ULNRC-05226

**DOCKET NUMBER 50-483
CALLAWAY PLANT
UNION ELECTRIC COMPANY
RESPONSES TO REQUESTS FOR
ADDITIONAL INFORMATION CONCERNING
LICENSE AMENDMENT REQUEST (LAR) OL-1258
FOR REVISION OF TECHNICAL SPECIFICATION 3.7.3,
"MAIN FEEDWATER ISOLATION VALVES (MFIVs)"**

RESPONSES TO NRC QUESTIONS REGARDING LAR OL-1258

MFIV Stroke Time Curves

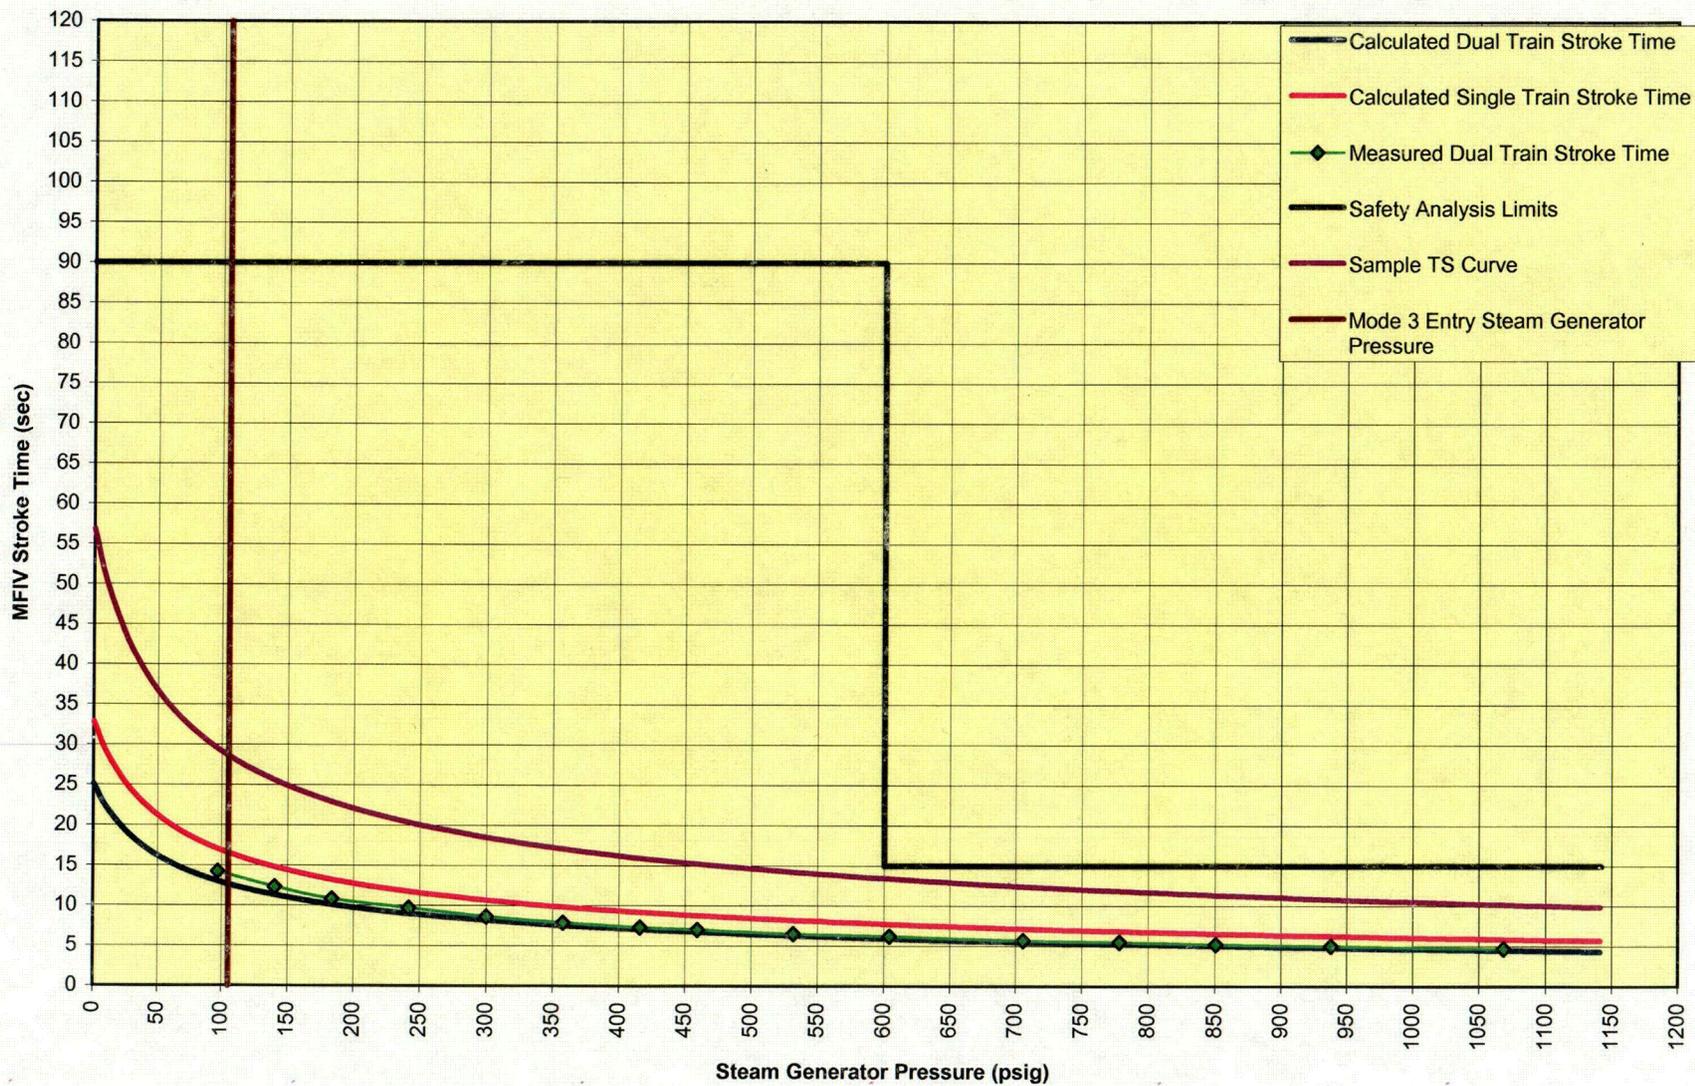
1. *The 15 seconds in the current SR 3.7.3.1 is based on the premise that any higher closure time would be an indication of degradation of the valve. Therefore, the NRC staff needs to know that higher closure times below 500 psig SG pressure (SGP) in the proposed Figure 3.7.3-1 would not be showing that the MFIV being tested has degraded.*

2. *What are the conditions that the MFIVs would be tested at to be in accordance with the proposed SR 3.7.3.3, and what is the basis that testing an MFIV at those conditions ensures that the valve closure times at other conditions would meet the proposed Figure 3.7.3-1?*

The main feedwater isolation valves (MFIVs) are tested under the Inservice Testing (IST) Program. Valves tested under the IST Program are governed by the testing requirements of the ASME OM Code. The ASME OM Code requires that stroke time test results shall be compared to the initial reference values or new reference values established for subject valves. Although the stroke-time limits for the MFIVs are being changed (pursuant to the license amendment request), the ASME OM Code test requirements will not change for the main feedwater isolation valves.

When comparing the stroke time test results to the initial reference values, the ASME OM Code specifies, for each type of valve (based on actuator type), the exact stroke time ranges to be used for stroke time acceptance criteria. If a valve fails to meet the stroke time acceptance criteria range, the valve shall be immediately retested or declared inoperable. If the valve is retested and the second set of data also does not meet the stroke time acceptance criteria range, the data shall be analyzed within 96 hours to verify that the new stroke time represents acceptable valve operation, or the valve shall be declared inoperable. If the second set of data meets the acceptance criteria, the cause of the initial deviation shall be analyzed and the results documented in the record of tests. Valves declared inoperable may be repaired or replaced, or the data may be analyzed to determine the cause of the deviation. The latter may yield a determination, in some cases, that the valve is operating acceptably. [ASME OM Code 1988 Part 10 Paragraphs 4.2.1.8 and 4.2.1.9]

When new reference values are established, the ASME OM Code specifies that reference values shall only be established when the valve is known to be operating acceptably. Deviations between the previous and new reference values shall be identified and analyzed. Verification that the new values represent acceptable operation shall be documented in the record of test. [ASME OM Code 1988 Part 10 Paragraph 3.3 and 3.4]

Therefore, although longer stroke times would be noted for the MFIVs at lower pressures (consistent with the characteristics of the system-medium actuators for these valves), application of the Code-required reference value and acceptance range for each MFIV will ensure that valve degradation is detected or investigated. This would be true for any test pressure since, as explained in the response to the next question, for a deviation seen at one particular test pressure a deviation would also be seen at any other test pressure (in relation to the characteristic stroke-time curve established for the MFIVs).

Per the proposed surveillance test procedure to be used for implementing SR 3.7.3.3, the MFIVs will be tested at a nominal system pressure (steam generator steam pressure) of approximately 100 psig (during Mode 4, prior to entry into Mode 3). As described in the response to Question 1 above, testing at this point will provide a reference stroke time value that will be used to establish the test acceptance criteria for each MFIV under the IST program.

As described in the amendment request, the proposed TS acceptance curve for SR 3.7.3.3 is based on the MFIV performance curve (provided as Attachment 6 to the September 9 amendment request). The shape of the performance curve reflects the operating characteristics of the MFIVs (with respect to how fast the valves may be expected to close at any pressure throughout the expected pressure range of operation). This curve was supported by testing done at the valve manufacturer, as well as field tests done at Callaway. In addition, and as also noted in the amendment request, the shape of the acceptance/performance curve(s) will be verified by baseline testing to be done during restart from the current refueling outage. [For the baseline testing, each MFIV will be stroked to close at five different pressures throughout the applicable pressure range. The measured stroke times will then be compared and evaluated to verify the shape of the performance/acceptance curve(s).] Since the acceptance curve is based on the characteristic curve for the valves, a deviation from the stroke time at one point on the acceptance curve would be expected to yield a proportional deviation from the stroke time at any other point on the curve.
